AGENDA
Planning and Zoning Commission
January 18, 2023 – REGULAR MEETING

ITEM P22-253: Development Plan for a new 3-story mixed use building at the properties addressed 245 and 265 N. Millward St. Continued to January 18, 2023 Planning Commission Meeting.

Meeting Date:	January 18, 2023	Meeting Title:	Planning Commission
Submitting Department:	Planning	Presenter:	Tyler Valentine
Agenda Item:	P22-269 & 278: Request for a Land Development Regulation (LDR) Text Amendment to Section 2.2.9 and fee waiver.	Public Comment:	Yes

Meeting Date:	January 18, 2023	Meeting Title:	Planning Commission
Submitting Department:	Planning Department	Presenter:	Tyler Valentine
Agenda Item:	P22-242 Development Plan for a future 2-lot subdivision of the property located at 180 Aspen Drive	Public Comment:	Yes

L0.3

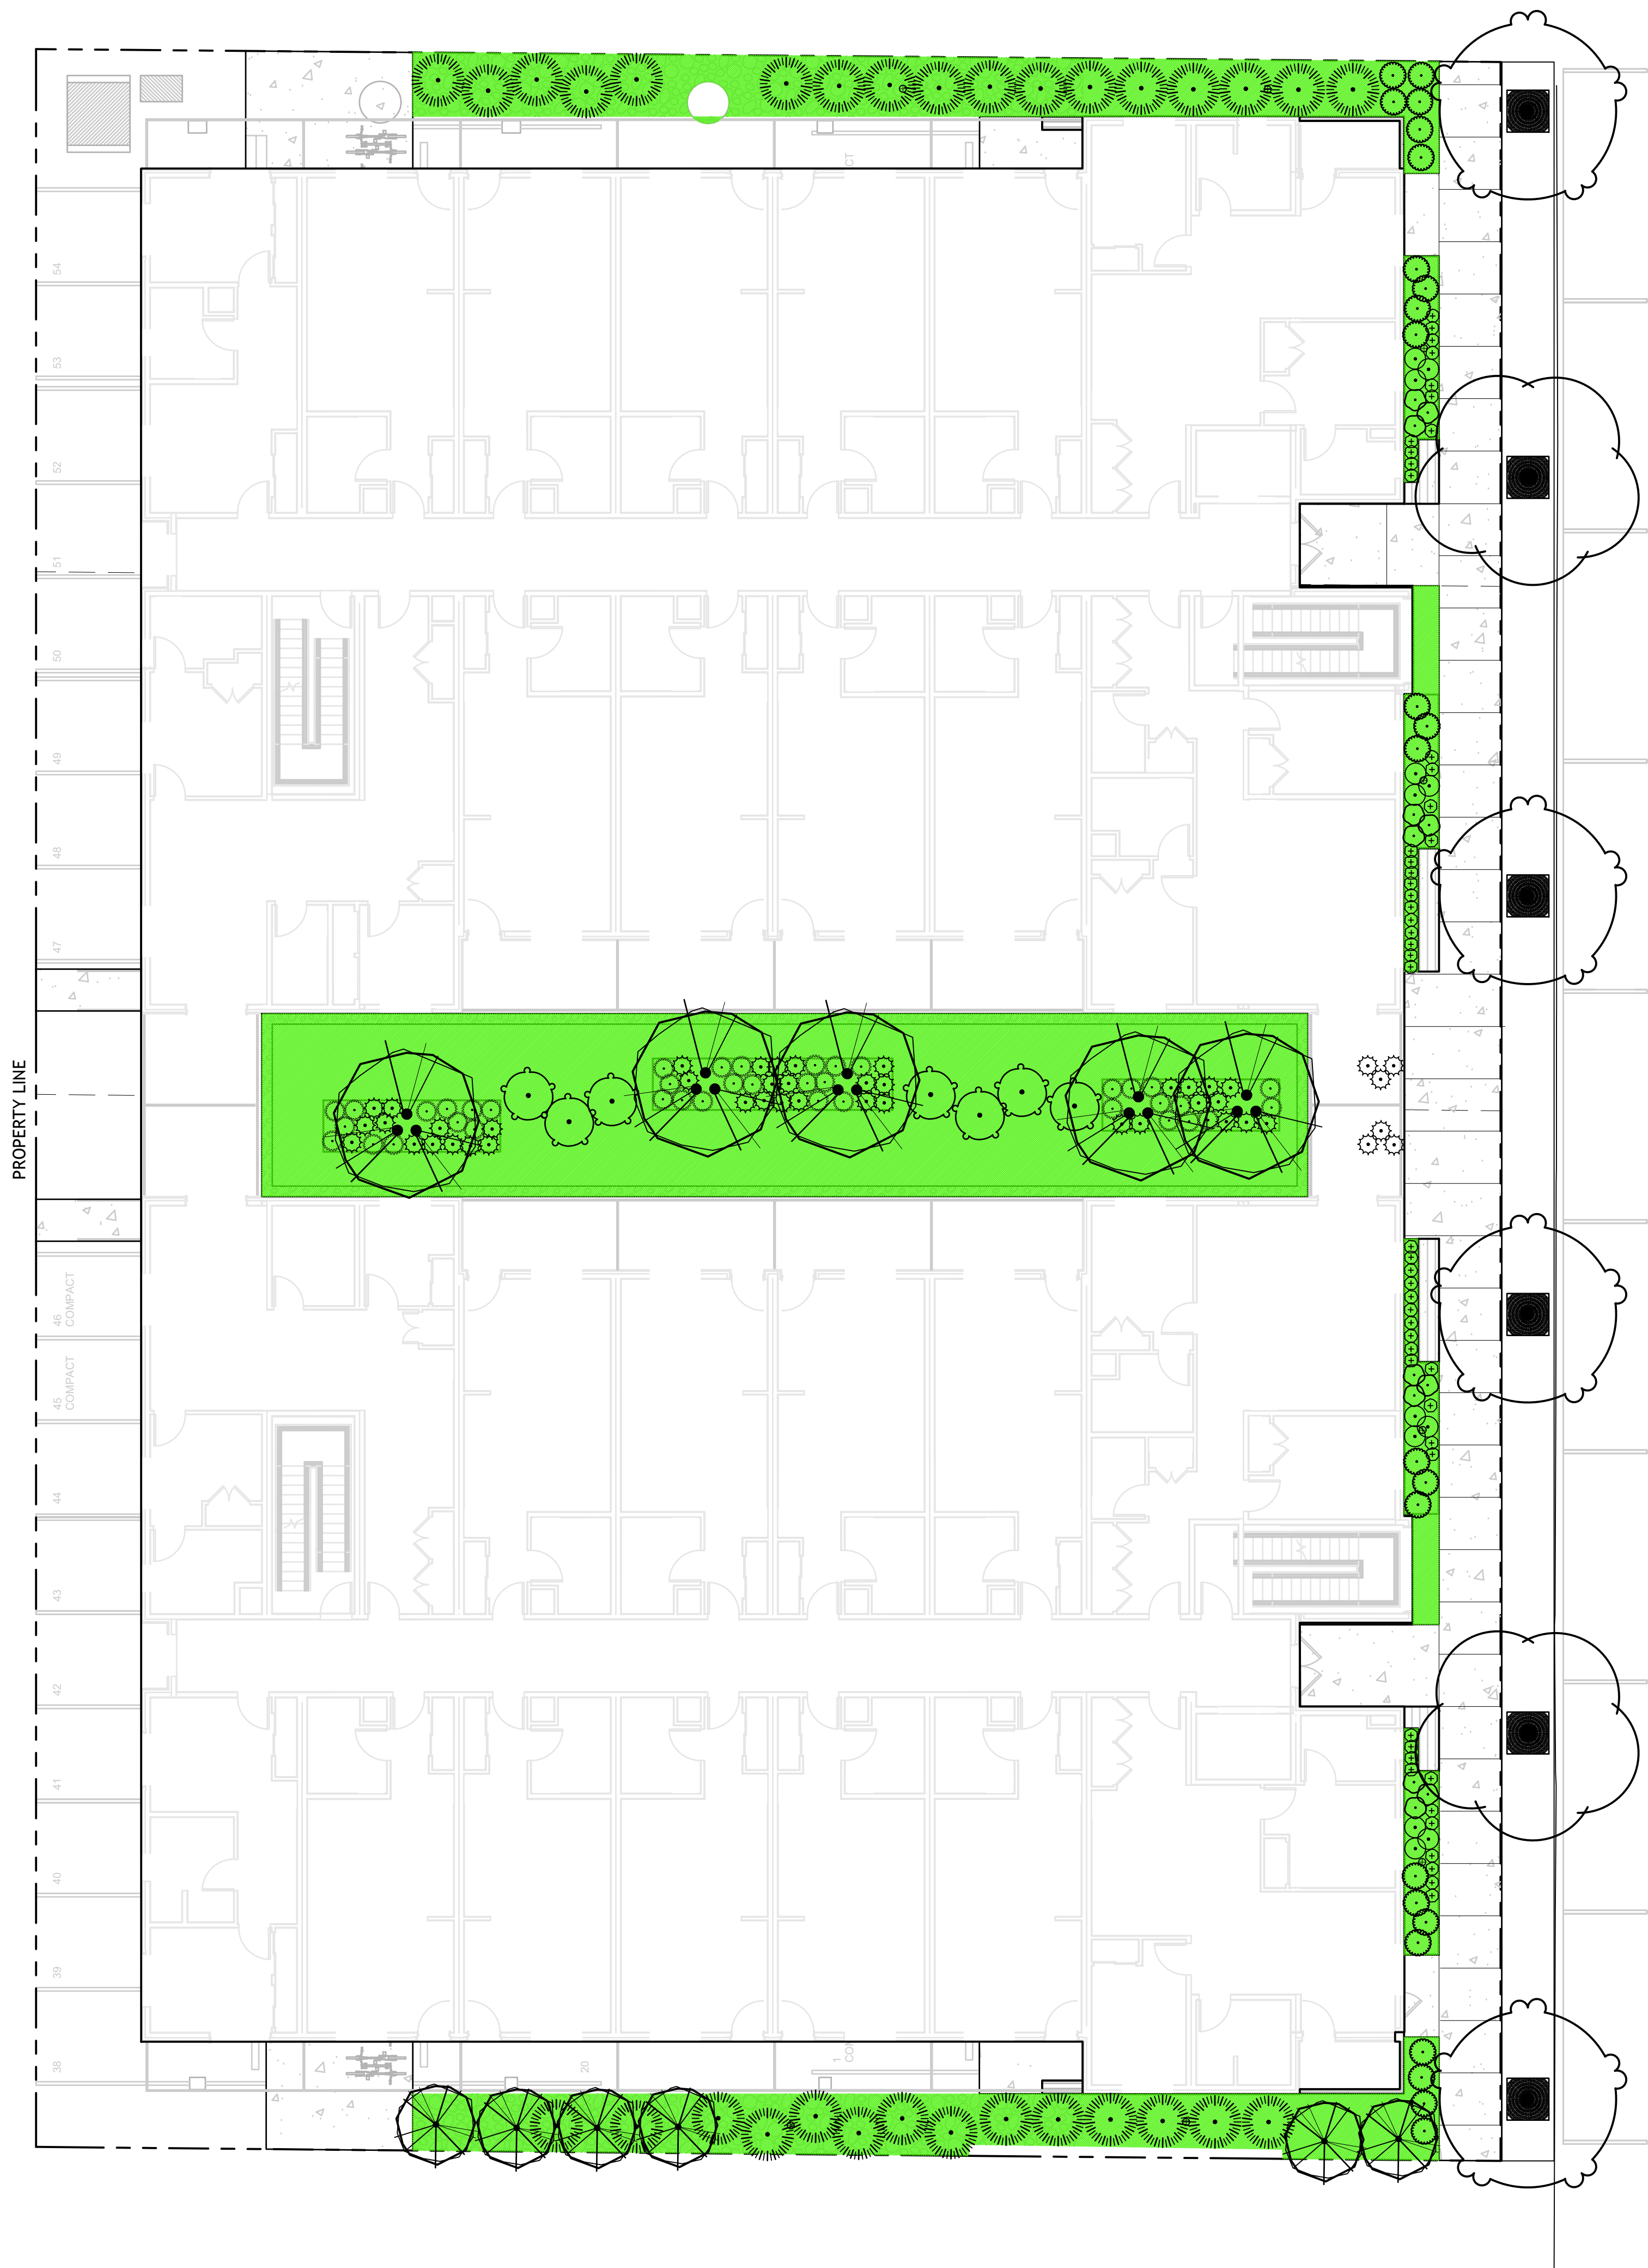
- LSR calculations (L0.6) appear to be calculated off “proposed structures” instead of Gross Site Area. Revise LSR calcs to base off gross site area. **Correct LSR calculations have been provided on L0.3, L0.4 and L4.0.**
- Landscape plan and LSR calcs will need to update to accommodate wider sidewalk and furnishing area required by “Trees-in-grates”. **All site plans have been updated to reflect the TOJ sidewalk and furnishing requirements for trees in grates.**
- Check landscape and site plans for consistency. Landscaping shown on landscape plans near alley corners but not shown on site plan. **Site and landscaping plans have been coordinated.**

L5.1

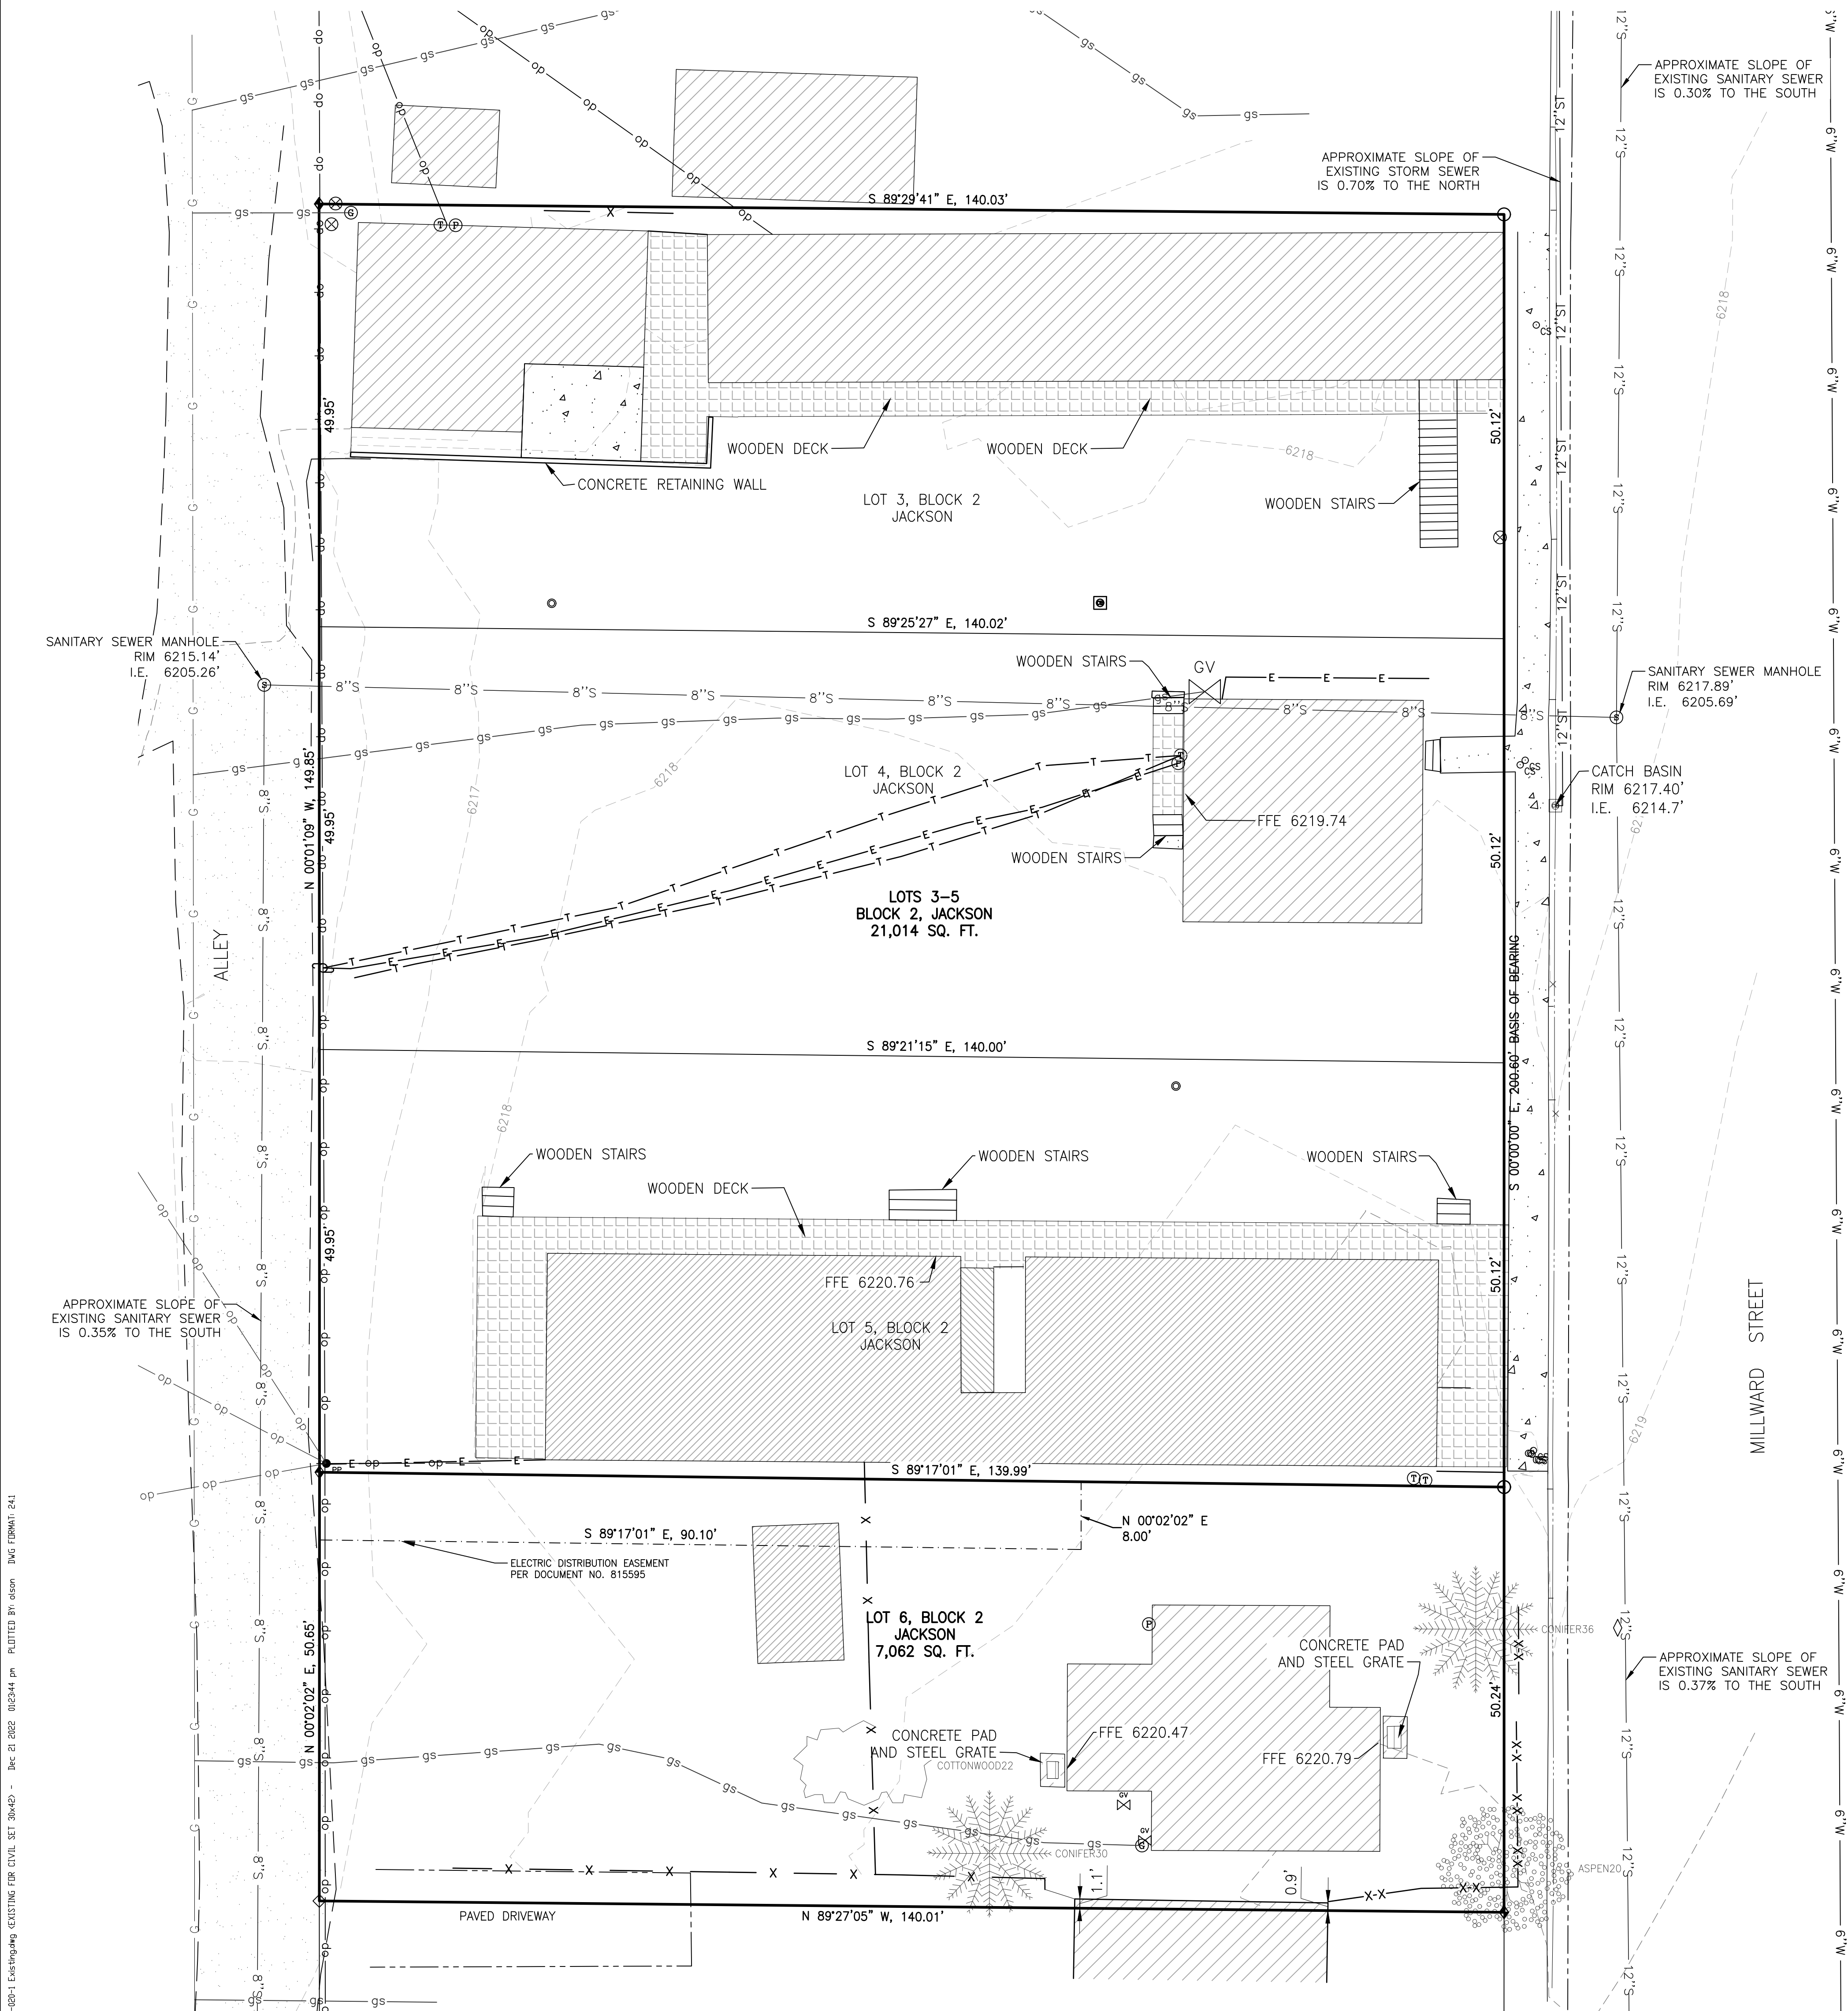
- Provide "native shrub" selection for Millward streetscape. **Plant Species have been added to L0.3 and L4.0.**
 - Would like to see a tree pit detail. **TOJ standard tree pit detail has been added to L5.1.**
 - Notification of clearance requirements for 5' wide clear zone on sidewalks and potential impacts/trimming requirements of species selection. **Sidewalk shown on all sheets have been updated to comply with TOJ standards. Shrubs and perennials are set back against building in raised planters and should not impact clear zone.**
-
